MINERALS PROGRAM INSPECTION REPORT**PHONE: (303) 866-3567**

MINE NAME: Cresson Project	MINE/PROSPECTING ID#: M-1980-244	MINERAL: Gold	COUNTY: Teller
INSPECTION TYPE: Monitoring	INSPECTOR(S): Patrick Lennberg	INSP. DATE: June 24, 2019	INSP. TIME: 08:30
OPERATOR: Cripple Creek & Victor Gold Mining Company	OPERATOR REPRESENTATIVE: Justin Bills	TYPE OF OPERATION: 112d-3 - Designated Mining Operation

Photo 11: AGVLF 10,200' level east area, arrows show ponding

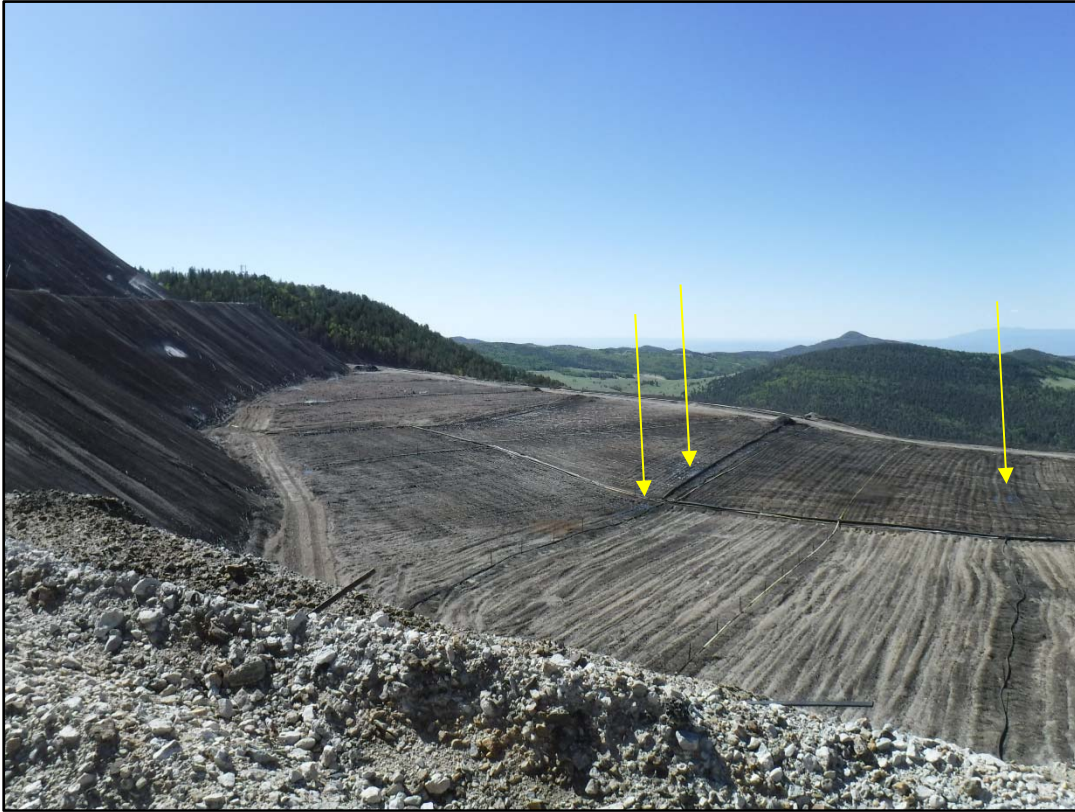
PROBLEM: A significant volume of process solution was ponded in the Squaw Gulch Valley Leach Facility. This is a potential attractant to wildlife. The surface area of the exposed fluid exceeded the permit condition (not to exceed 3 feet x 3 feet area).

The current and maximum elevation of ore placement in the AGVLF is 10,400 feet (for Phase V). The Division inspected active leaching surfaces on the AGVLF. These surfaces were well saturated and ponding of leachate, greater than 3 feet by 3 feet, was common. In addition, ponding of leachate was observed on the lower 10,200 foot level, although not as common as was observed on the upper level. During the close-out meeting the Operator indicated that the application rate of leachate had been reduced by approximately 120 gpm in these areas. Also, a crew that was observed on the 10,200 foot level was moved to the upper level to begin ripping the material to promote infiltration. While the weather in the recent past had been wet this was not a significant factor in the ponding. Finally, during an aerial inspection in early June there were several areas of ponding noted including the areas observed during this inspection. A problem is being cited in this report due

to the ponding observed in excess of the 3 foot by 3 foot requirement.

CORRECTIVE ACTIONS: Provide the Division with photographic evidence that measures were taken to allow the solution within this area to infiltrate into the pad or other wildlife mitigation measures have been employed by the corrective action date.
